SERVICE BULLETIN 03 (Reprint)

FROM: Field Service Dept., Data East Pinball, Inc.
TO: Service Managers
DATE: April 20, 1988
RE: Laser War - Improvements (Spinning Targets, Pop Bumpers, Game Program, Flippers & CPU Board)

FIG. 1

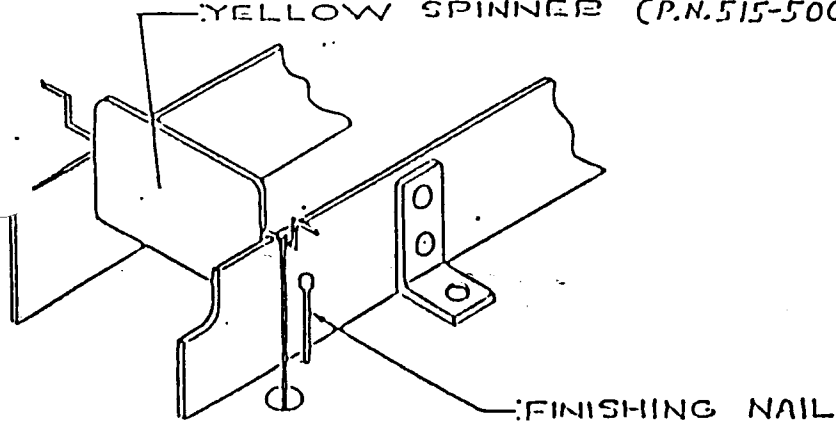
1. Early spinners used a light gauge pivot wire which may break. Spinners presently being used have been updated to a heavier gauge.
2. The right ball rail in the yellow spinner lane may eventually be bent by ball hits causing it to apply pressure to the spinner actuator rod. A finishing nail has been added behind the rail to prevent movement (Refer to Fig. 1).

FIG. 2

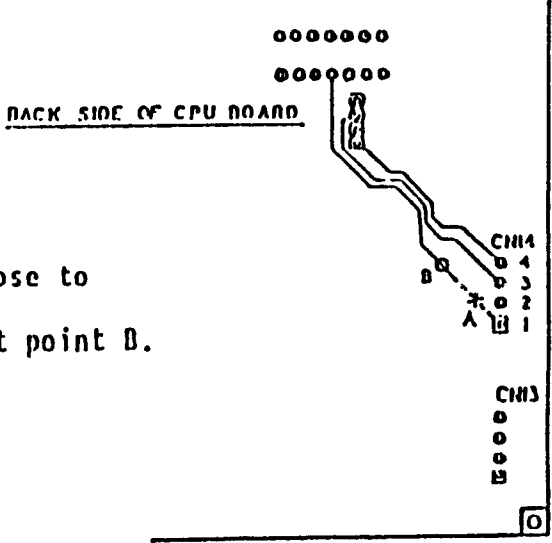
After receiving some calls on various problems that appeared to be CPU Board related, it was noticed that the memory interlock circuit had improper filtering at the connectr input from the memory interlock switch on the coin door. We are adding the proper filter network and recommend you make this change to your CPU Boards (Refer to Fig. 2).

1. Cut trace (shown as X) at point A close to Pin 1 of CN 14.
2. Scrape solder mask from same trace at point B.
3. Refer to Fig. 3
